****MANDATORY****
SERVICE BULLETIN
NO.: 21107 Rev A

TO: Garmin G5 Electronic Flight Instrument Aircraft Owners and Service Centers
DATE: December 21, 2021
SUBJECT: G5 Software Version 7.70

Battery Status

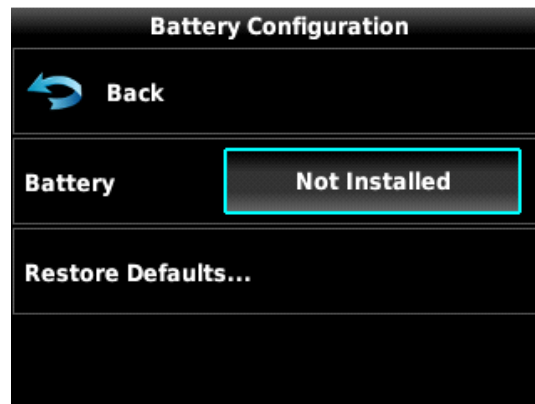
1. Push and hold down the knob while applying aircraft power to enter configuration mode.
2. Navigate to the battery status page:
 - a) If the Battery Status field displays 'Charging', no further action is required. Skip to Step 3.
 - b) If the Battery Status field does not display 'Charging', within 1 minute, contact Garmin Experimental Product support for a battery exchange. Repeat this procedure once a new battery is installed.

Valid Battery Indication

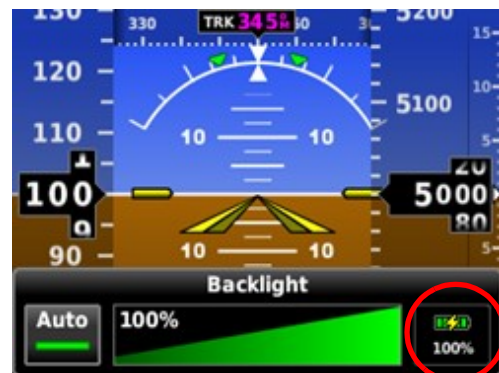
3. Remove aircraft power.
4. Apply aircraft power to enter Normal mode.
5. Push the power button to confirm the presence of a valid battery indication.
